**From:** [Trish Spencer](#)  
**To:** [Lara Weisiger](#)  
**Subject:** Fw: May 7 agenda, Item 7-D  
**Date:** Monday, May 6, 2024 12:47:33 PM  
**Attachments:** [Main - W Atlantic.xlsx](#)  
[image005.png](#)  
[image006.png](#)  
[image007.png](#)  
[image008.png](#)  
[image009.png](#)

**From:** Trish Spencer <[tspencer@alamedaca.gov](mailto:tspencer@alamedaca.gov)>  
**Sent:** Monday, April 29, 2024 2:22 PM  
**To:** Jennifer Ott <[jott@alamedaca.gov](mailto:jott@alamedaca.gov)>  
**Cc:** Yibin Shen <[yshen@alamedaca.gov](mailto:yshen@alamedaca.gov)>; Erin Smith <[ESmith@alamedaca.gov](mailto:ESmith@alamedaca.gov)>  
**Subject:** May 7 agenda, Item 7-D

Exhibit 2 - Locations of temporary asphalt curbs. Please note that Exhibit 2 was only intended to show generally where the asphalt curbs will be considered as part of the design. Actual design elements are noted below in the various responses.

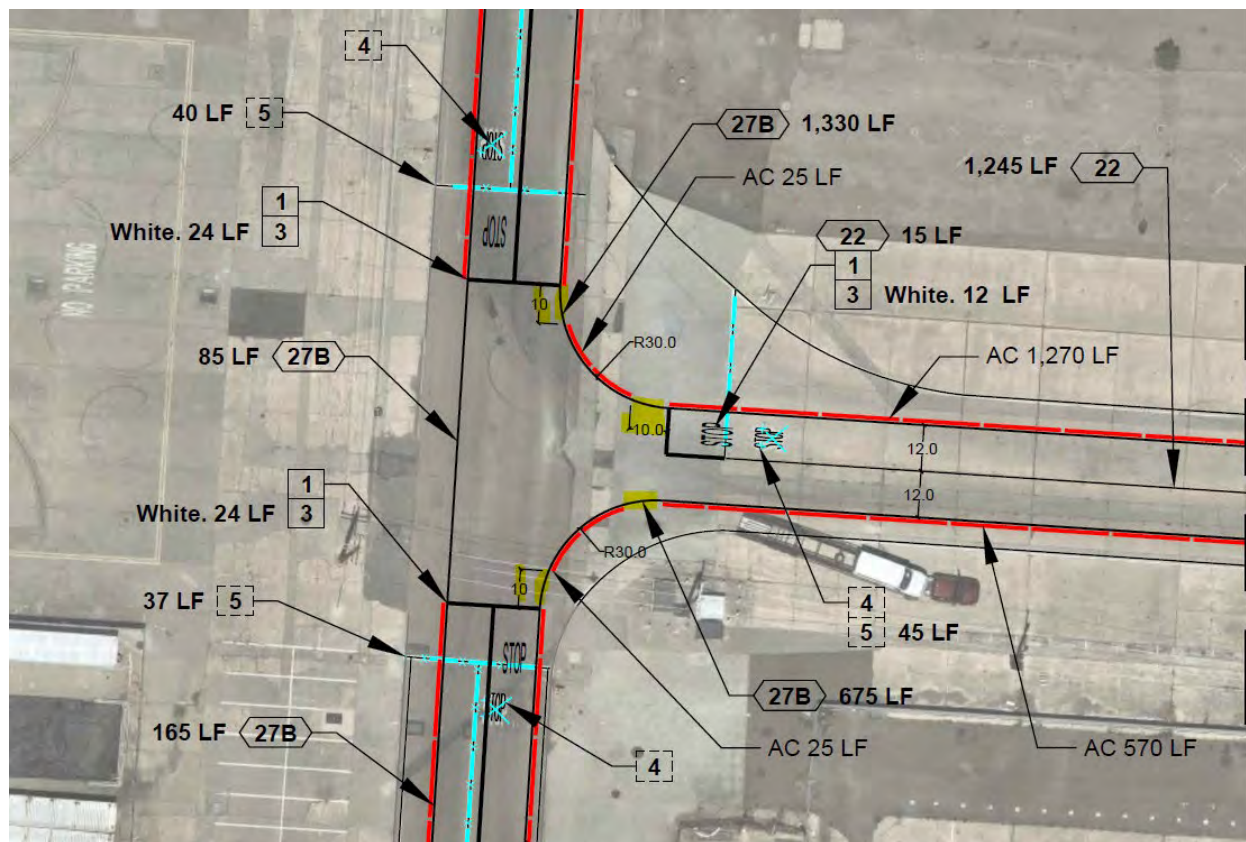
My concerns include not visible, easily tripped over, run into, prohibits current biking and pedestrian movement/flow. Dangerous. The ends of each 20-foot section of curb will either be painted white or have a white reflector installed on top of the curb. In addition, there will be a solid white line marking the right edge of the road. See the answer below for bike/ped movement.

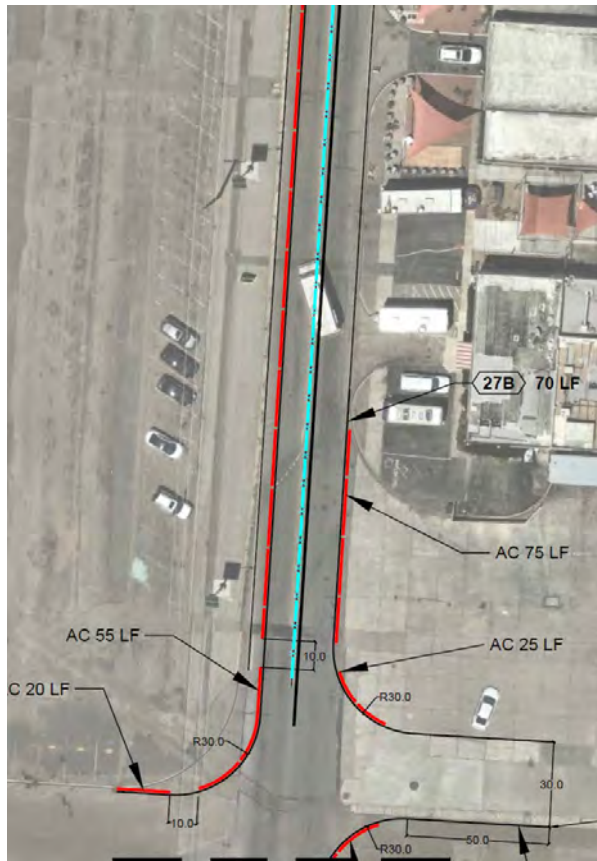
Pedestrians walk back and forth across streets and will have to step over or trip, including in the dark. Some have strollers, wagons, etc. Pedestrians are encouraged to cross streets at intersections. 10-foot-wide openings are provided at each intersection, consistent with a typical crosswalk width. Should a pedestrian wish to cross mid-block, they can walk through one of the 2-foot-wide openings between asphalt curb lengths or choose to step over the curb. This is functionally no different than the ultimate roadway configuration in the MIP or most other streets within Alameda. Shown below is another example of an opening to cross Monarch.

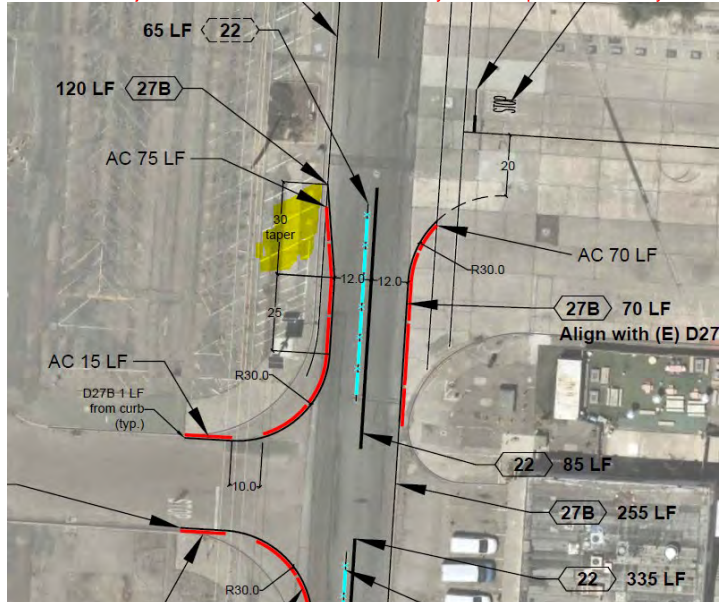
When Rock Wall was open, they regularly had events where people would park across the street. There appears to be small cutouts at both ends. Is that the City's plan to have people access area through those cutouts? If so, what are lengths of openings? Can measurements of openings be added to pic? Pedestrians are encouraged to cross streets at intersections. 10-foot-wide openings are provided at each intersection, consistent with a typical crosswalk width. Please see the image above of the W Tower and Monarch intersection.

There was recently an event on side of building near Urban Legend and people parked by Tower and across from that building. Will there still be an opening to drive into parking across from Tower lot? If so, how long? Dimensions of openings are missing. Parking at the southern end of Monarch Street will be unaffected.

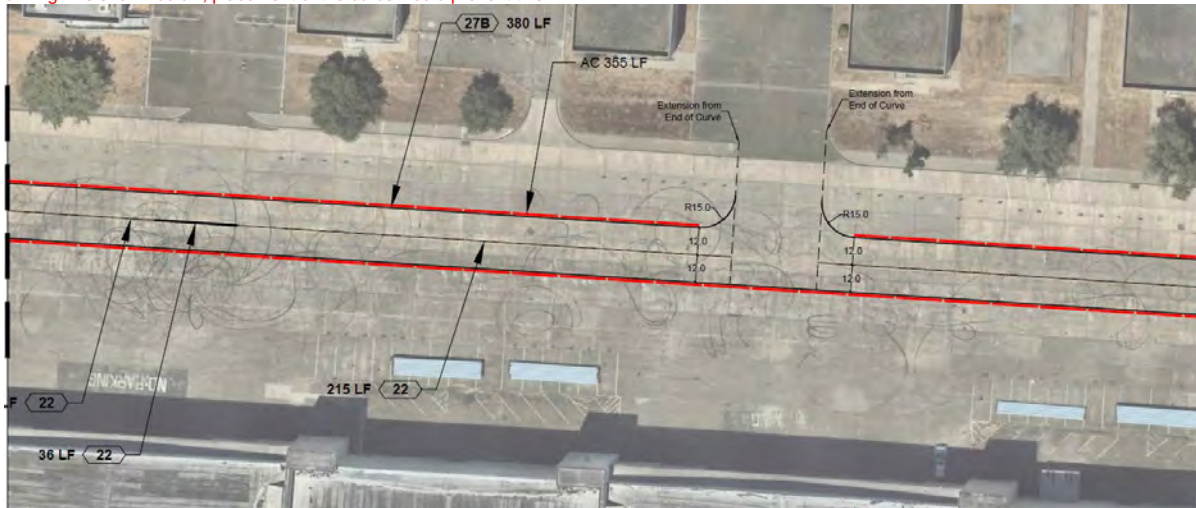
Why not add sidewalk now? Adding sidewalk now is cost prohibitive. Doing so will take place as part of the planned backbone improvements under design now. Assuming the City sells buildings at Alameda Point or otherwise secures construction dollars, the full street reconstruction is expected to be underway in 2026.

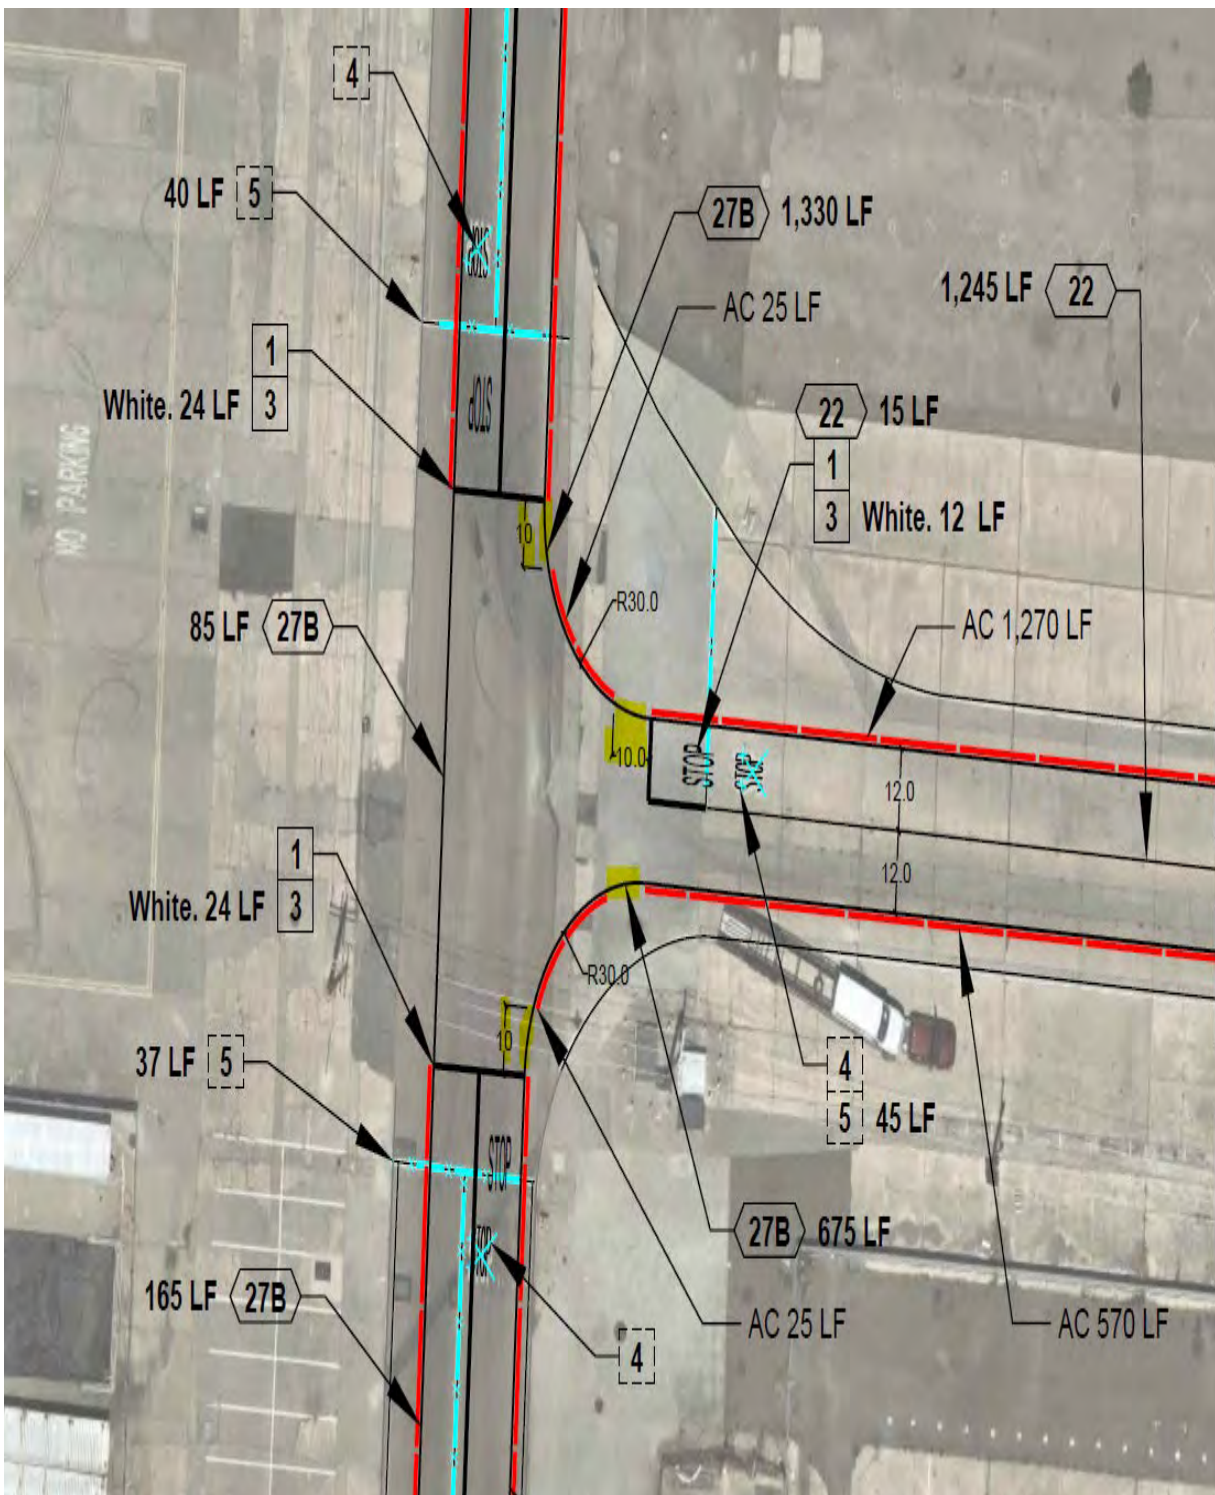
My concerns include not visible, easily tripped over, run into, prohibits current biking and pedestrian movement/flow. Dangerous. The ends of each 20-foot section of curb will either be painted white or have a white reflector installed on top of the curb. In addition, there will be a solid white line marking the right edge of the road. See the answer below for bike/ped movement.

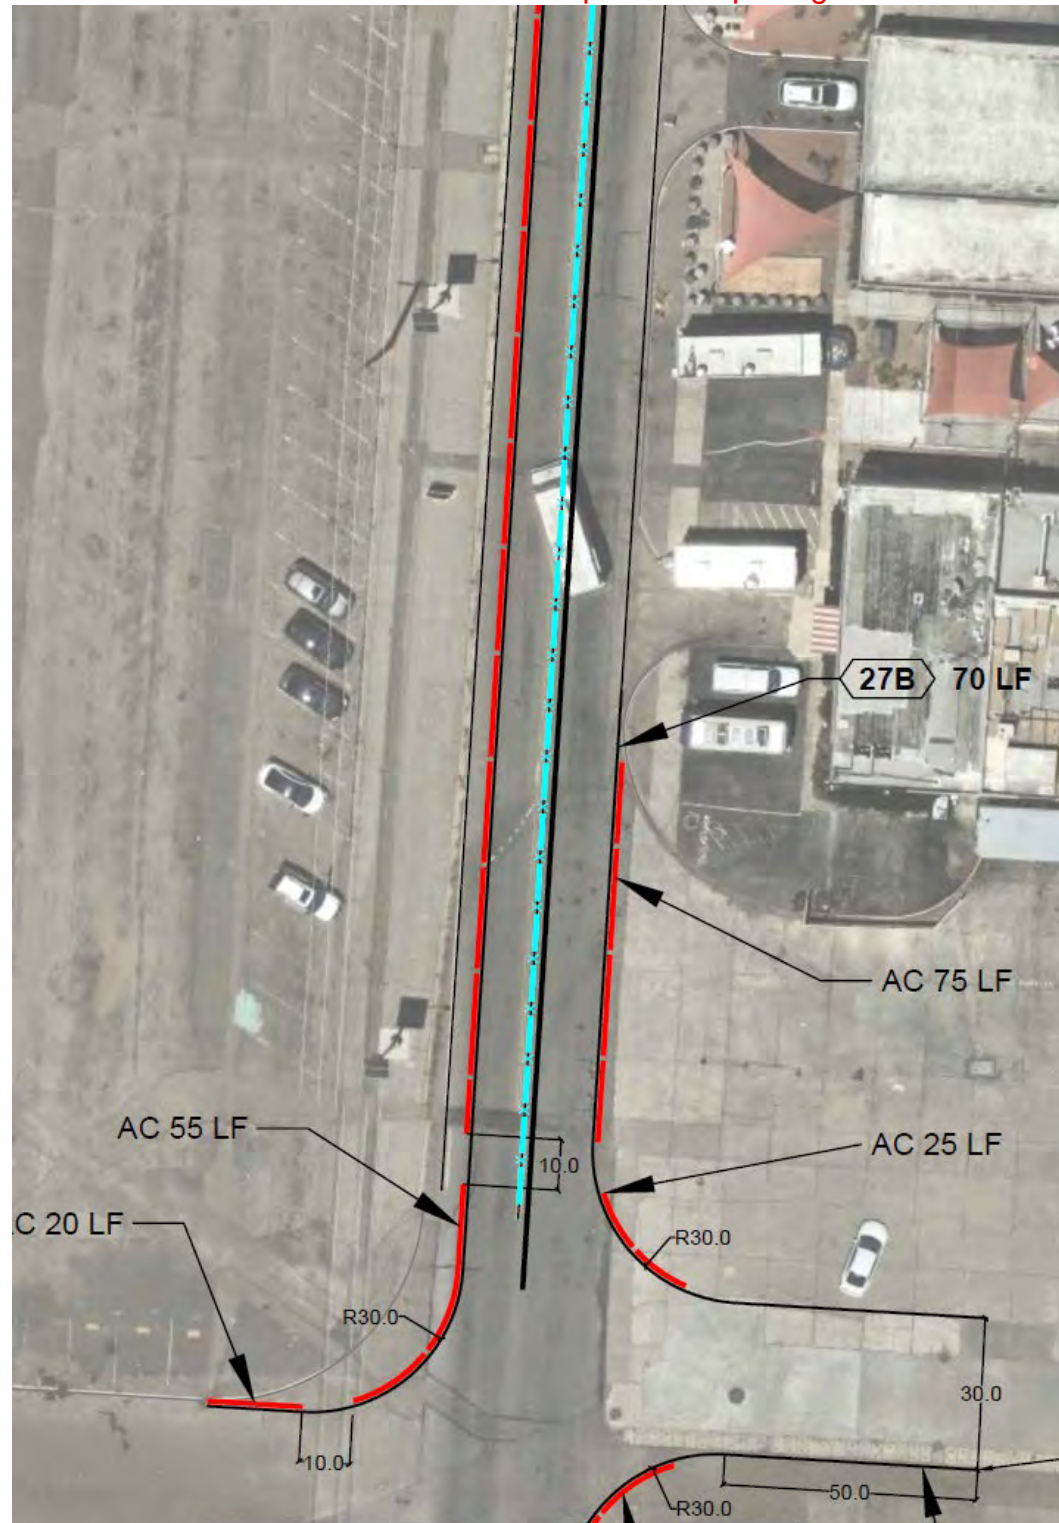
Pedestrians walk back and forth across streets and will have to step over or trip, including in the dark. Some have strollers, wagons, etc. **Pedestrians are encouraged to cross streets at intersections.** 10-foot-wide openings are provided at each intersection, consistent with a typical crosswalk width. Should a pedestrian wish to cross mid-block, they can walk through one of the 2-foot-wide openings between asphalt curb lengths or choose to step over the curb. This is functionally no different than the ultimate roadway configuration in the MIP or most other streets within

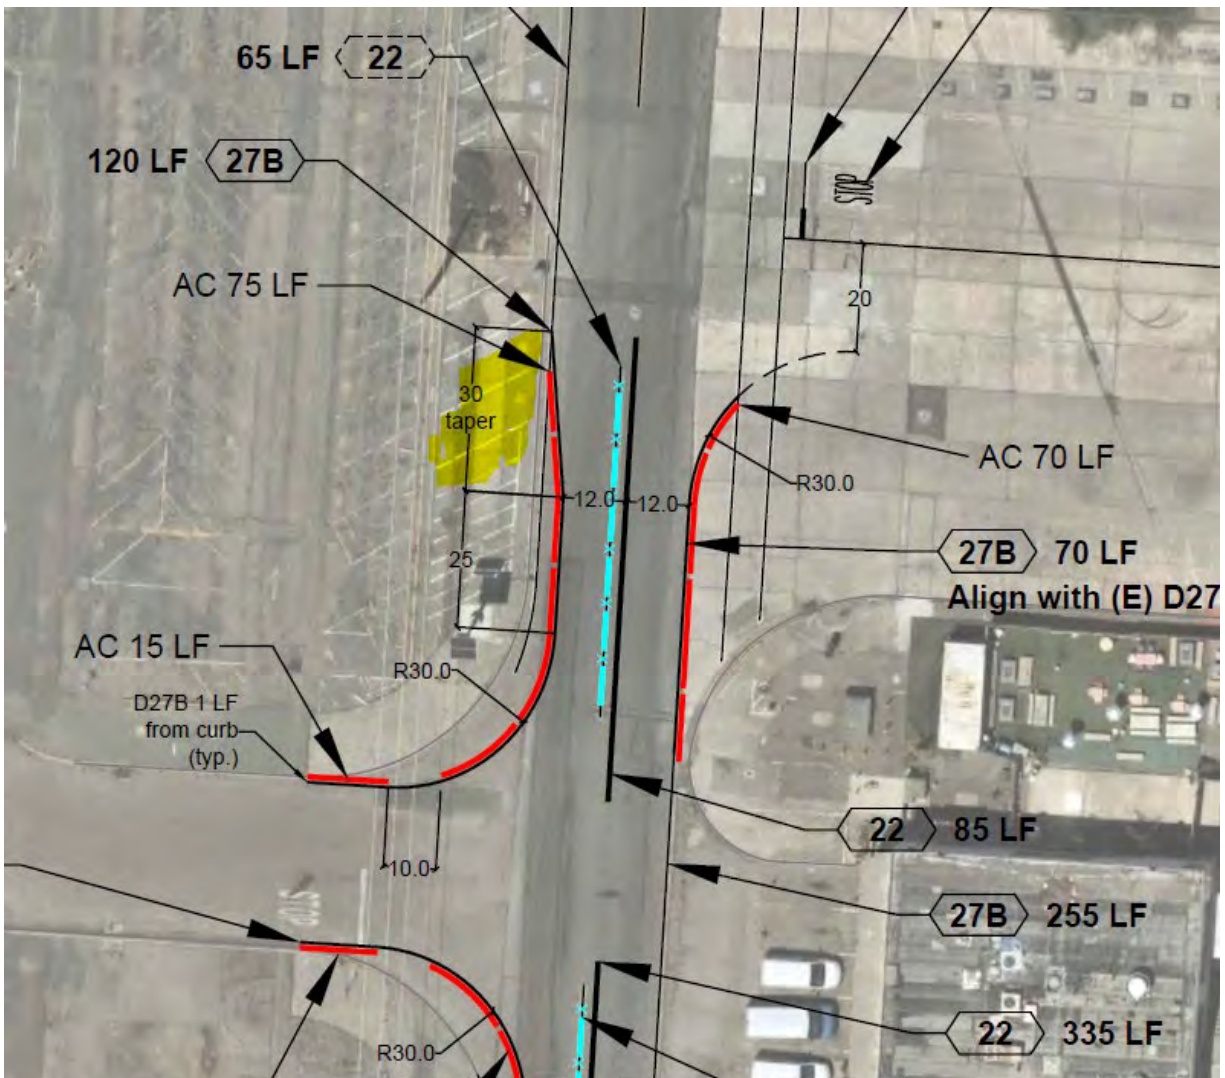
There was recently an event on side of building near Urban Legend and people parked by Tower and across from that building. Will there still be an opening to drive into parking across from Tower lot? If so, how long? Dimensions of openings are missing. **Parking at the southern end of Monarch Street will be unaffected.**

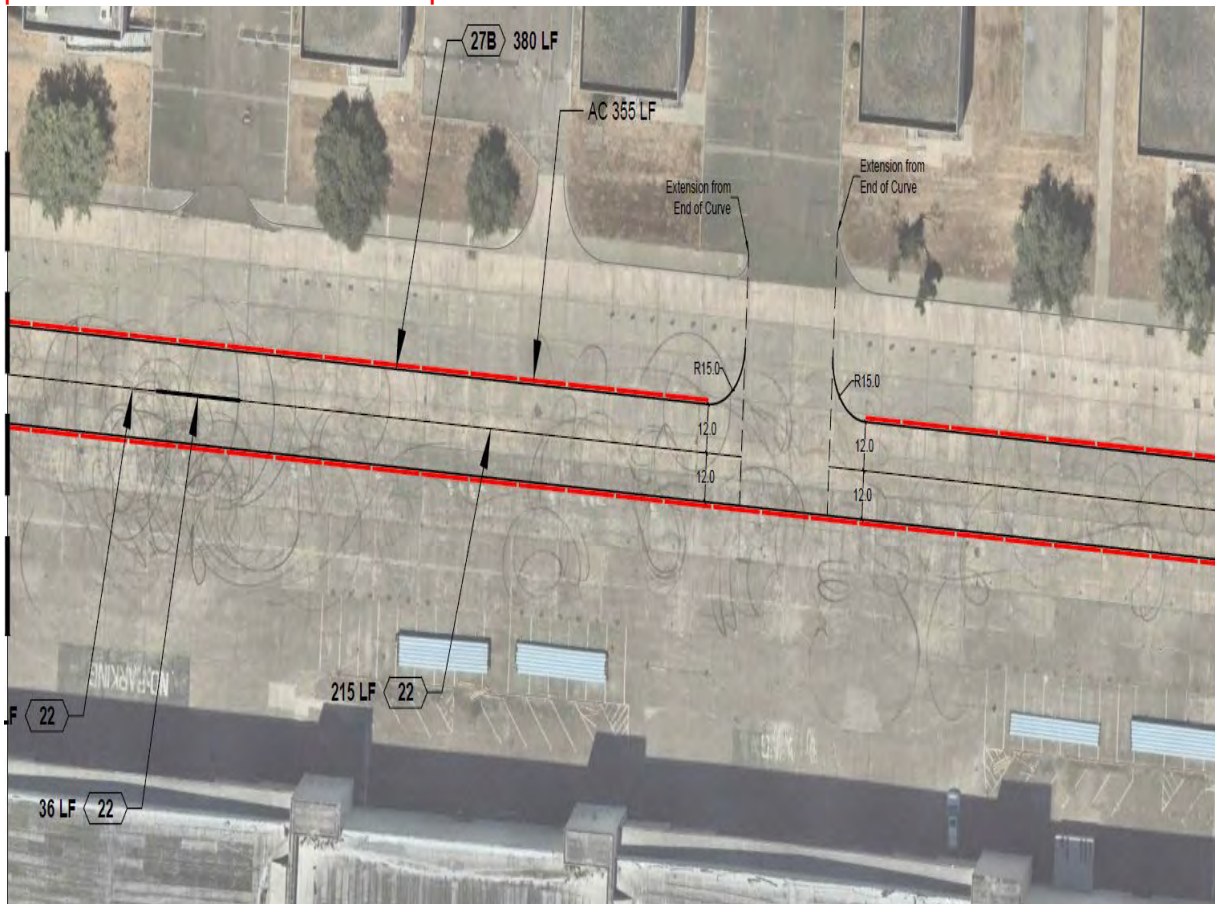
Why not add sidewalk now? Adding sidewalk now is cost prohibitive. Doing so will take place as part of the planned backbone improvements under design now. Assuming the City sells buildings at Alameda Point or otherwise secures construction dollars, the full street reconstruction is expected to be underway in 2026.
